**Pill Station and
Ashton Vale Industrial Estate
alternative access
micro-consultations report**

MetroWest Phase 1

June 2016

Option-1
As consultation
summer 2015

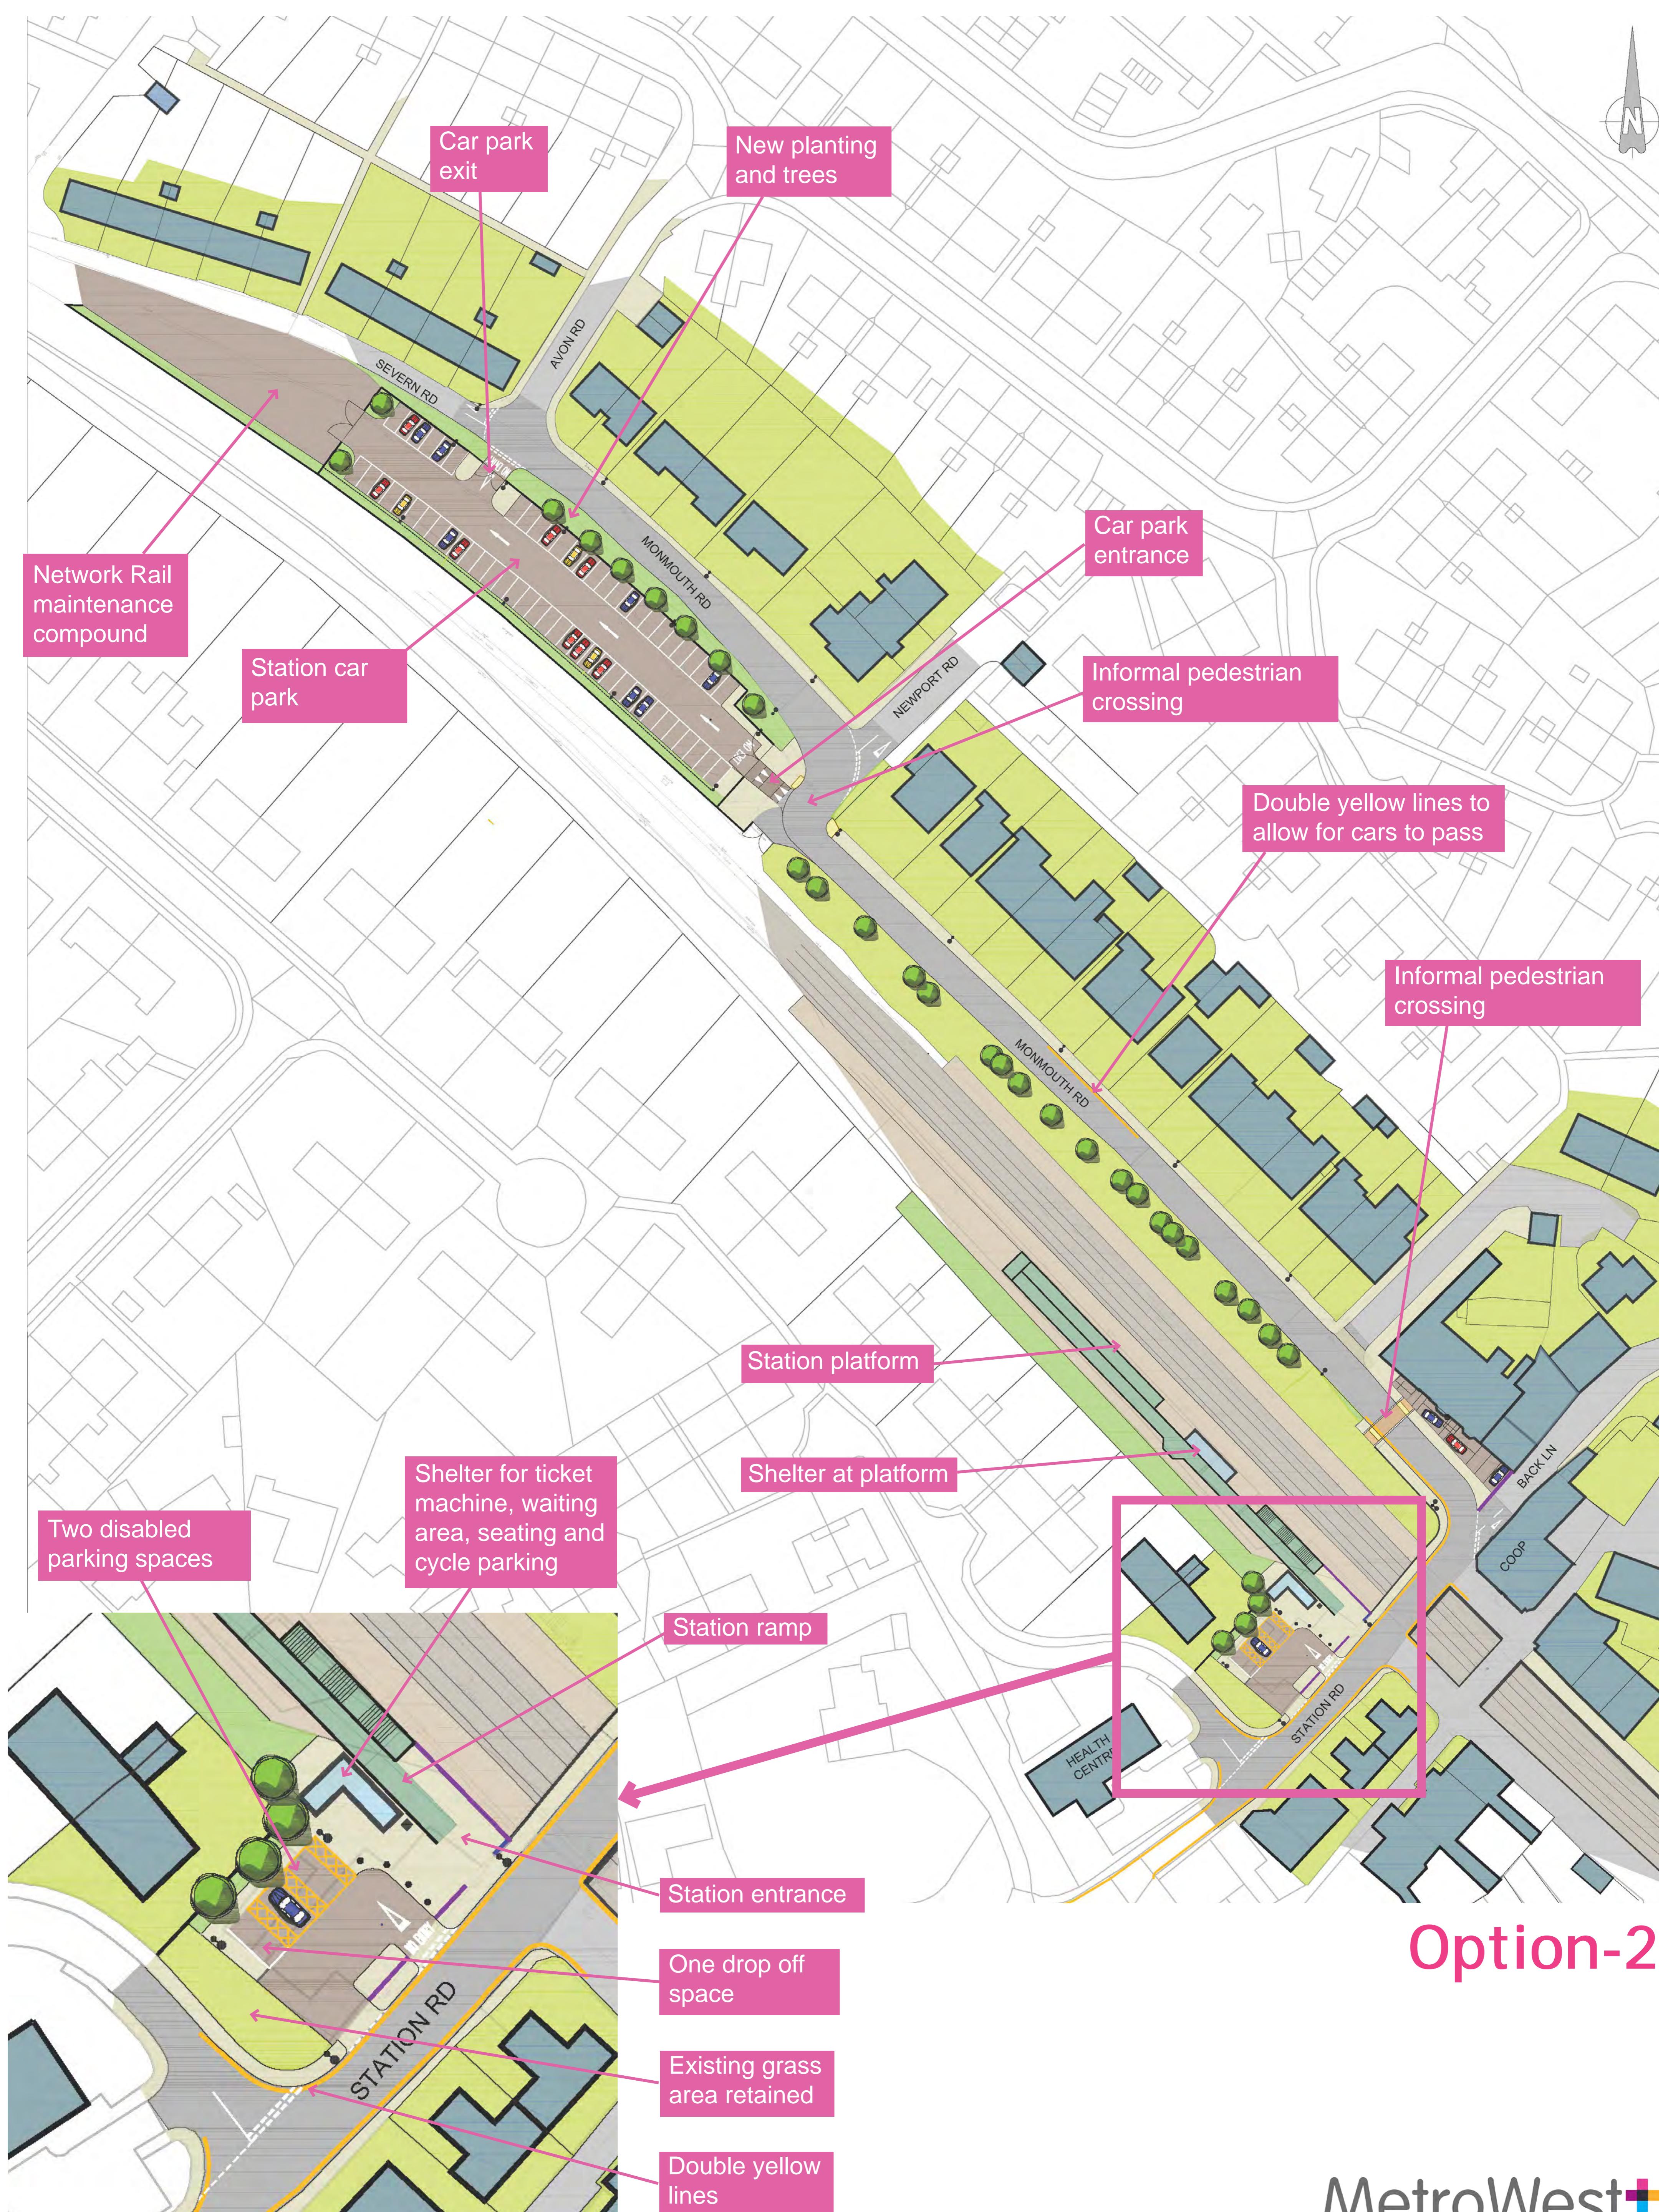
3.9 The most popular design was option 4, with more than double the number preferring it to the second most popular (option 3). However the majority of respondents stated a preference for the use of the old station house as a forecourt regardless of layout i.e. options 2 – 4, rather than option 1. Two respondents opposed option 1 entirely.

Option-1

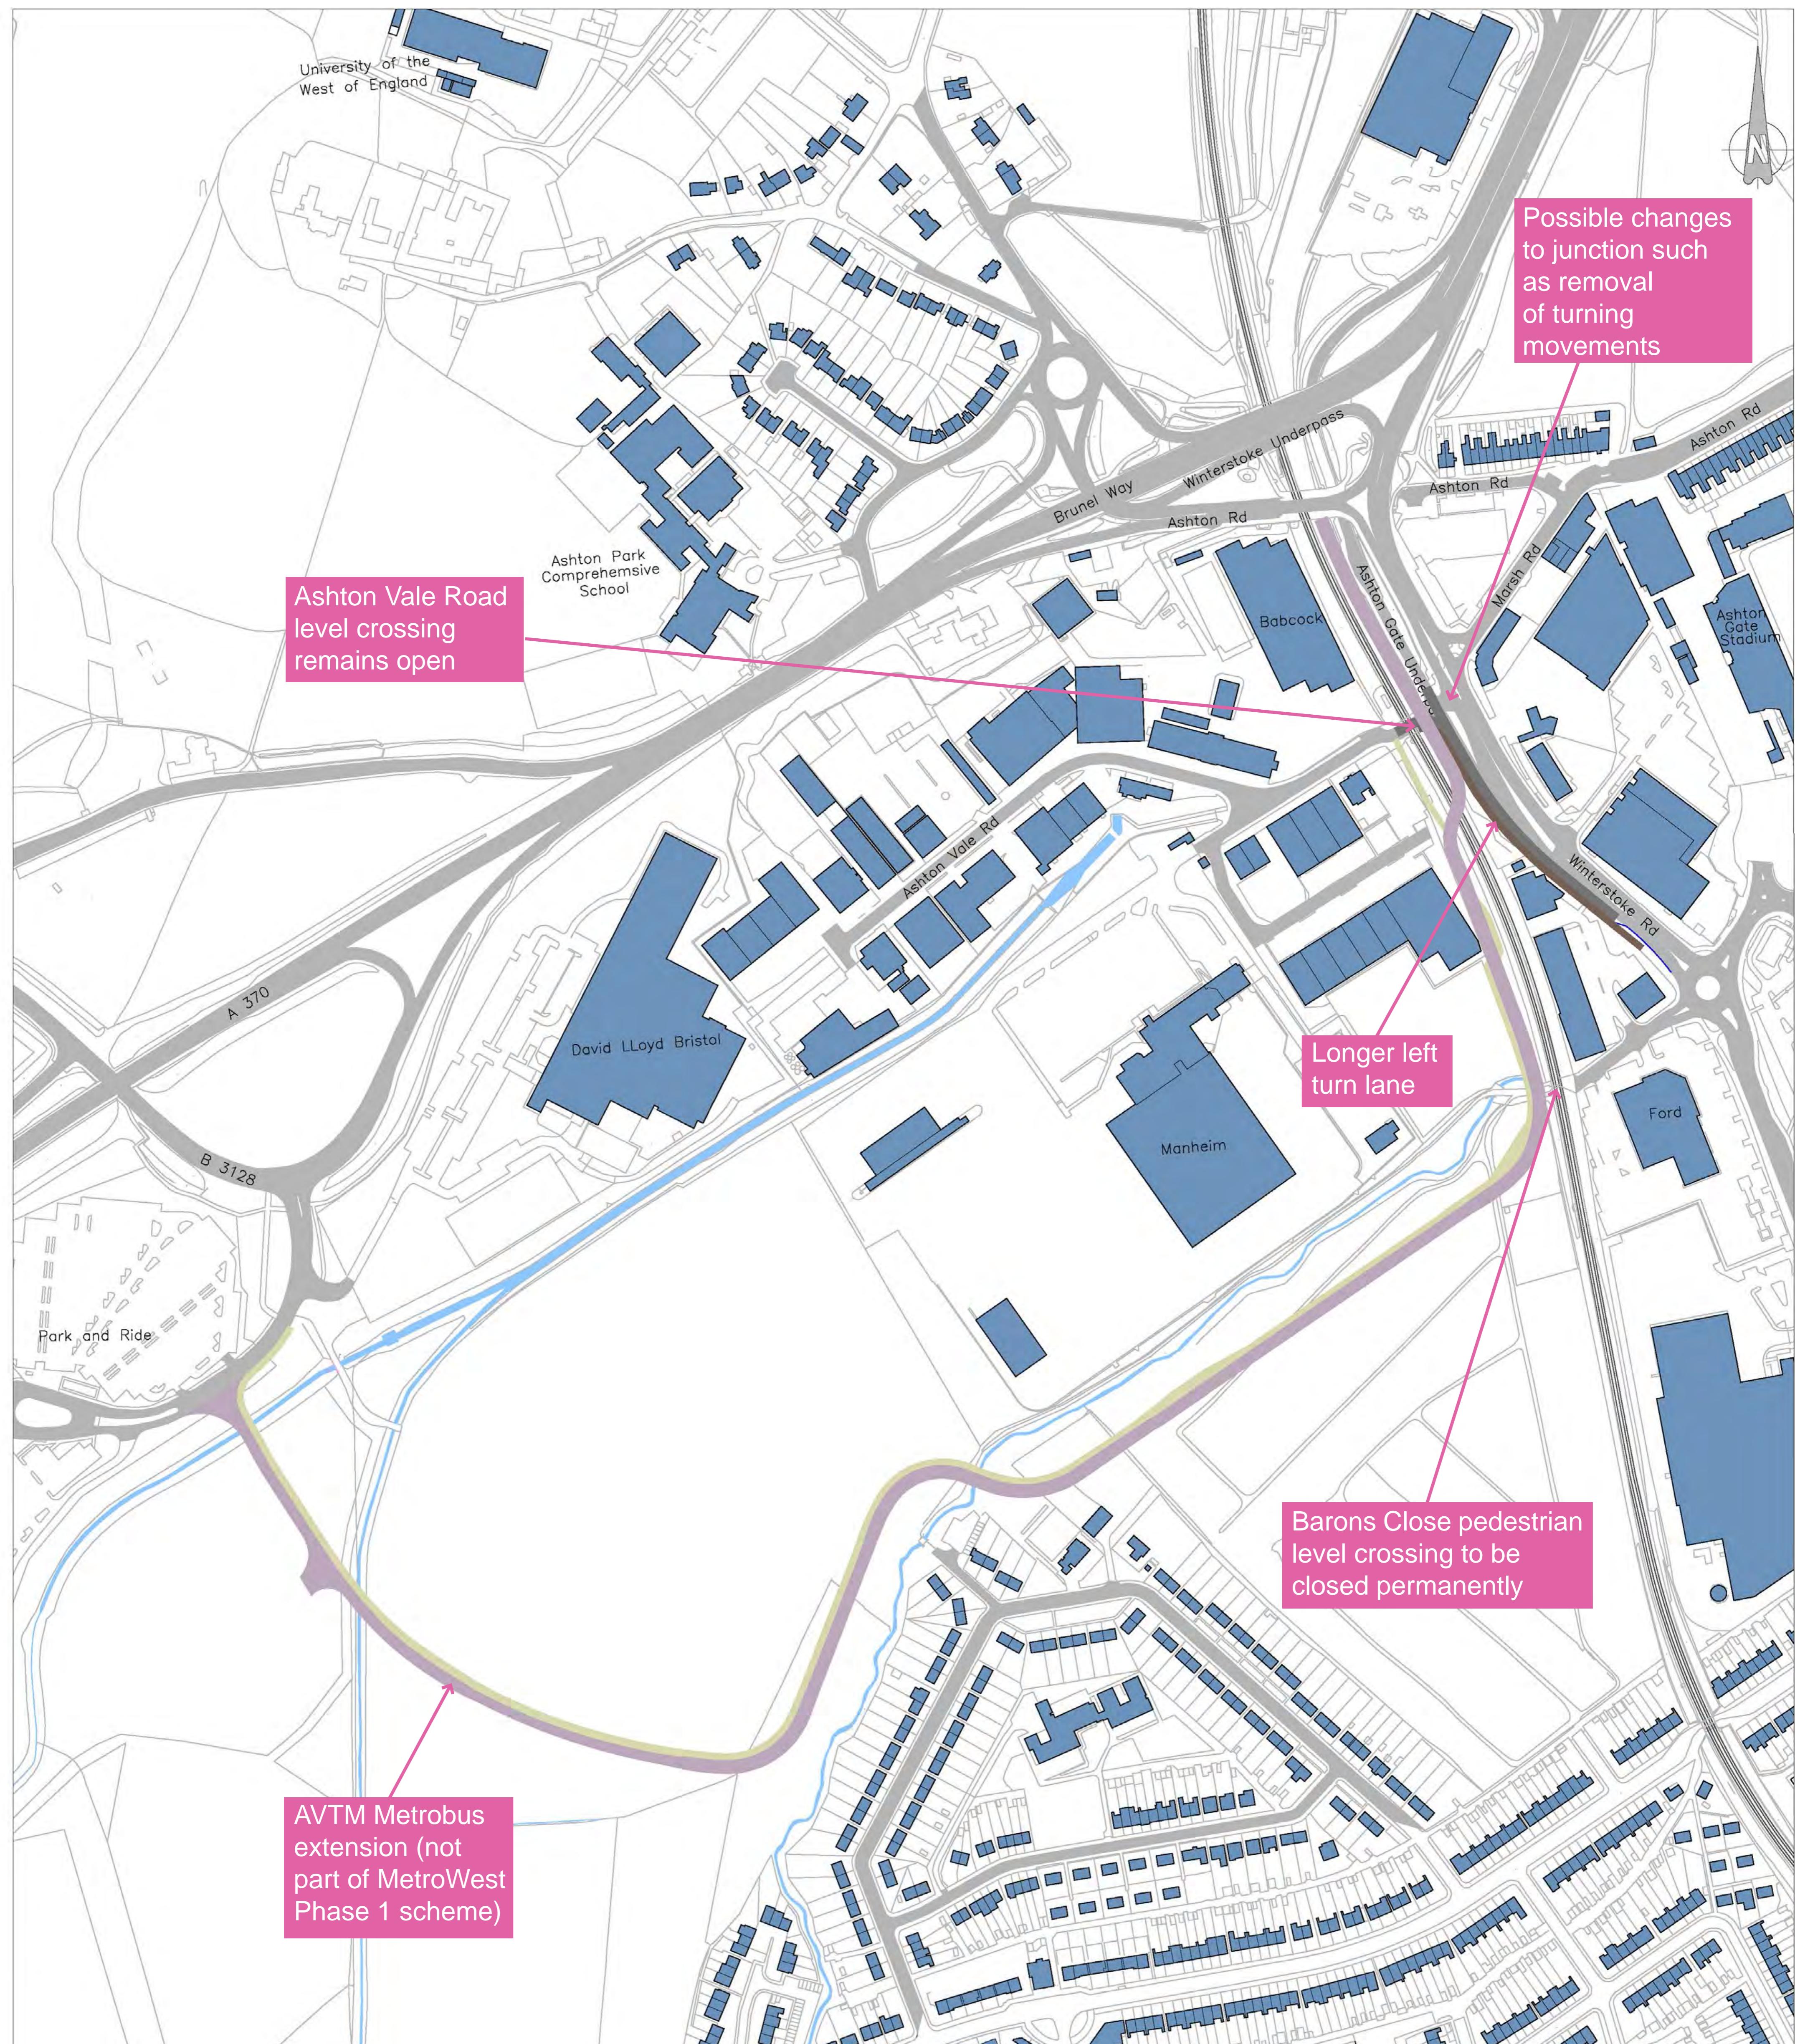
3.17 There was little support for option 1 which was to retain access via the level crossing only and accommodate queueing vehicles on an extended lane on Winterstoke Road. However a significant number wished for the level crossing to remain open to vehicles and pedestrians as well as providing new accesses, rather than being permanently closed.

- Bristol Port – object to Option 1 and believe that the level crossing should be permanently closed to accommodate increased future freight train use;

Subject	From	Comment
Option 1	Affected business	Option 1 unlikely to be sufficient to deal with delays caused by increased barrier down time.
	Affected business	Option 1 is a non-starter which would have a major impact on viability and profitability and would impact jobs. We formally object to this option.
	Affected business	Option 1 is no option at all for commercial businesses on the estate and must not be contemplated.
	Affected business	A barrier down time of 20 minutes each hour would have a very detrimental effect on our business and pose real safety risks.
	Affected business	A total barrier down time of 20 minutes each hour at the existing road junction would be a logistical nightmare for us and our suppliers, and would have a very detrimental effect on our business. It would also pose real safety risks. We do not object to the closure of this junction combined with a replacement access road to the west.

Member of public	Option 1 will cause a lot more traffic problems than it will solve.
	Affected landowner	The Ashton Vale Level Crossing must be retained. If the level crossing is destined to be operating for 40 uninterrupted minutes per hour then it has to be suitably safely modified (with possible stacking lanes on Winterstoke Road approaches) together with the rear access routes shown in combination on Options 4 or 5.
Option 2	Affected business	Option 2 preferred.
	Affected business	Option 2 takes valuable land away from Manheim which will have an impact on the business in terms of causing an operating capacity reduction. All traffic (including car transporters) would need to travel a lengthy route almost the full length of Ashton Vale Road.
	Affected business	If Option 2 were to be implemented we would favour a land swap arrangement where alternative land could be provided to mitigate the loss of land subject to CPO. We would also like to discuss a new direct access on to the new road.
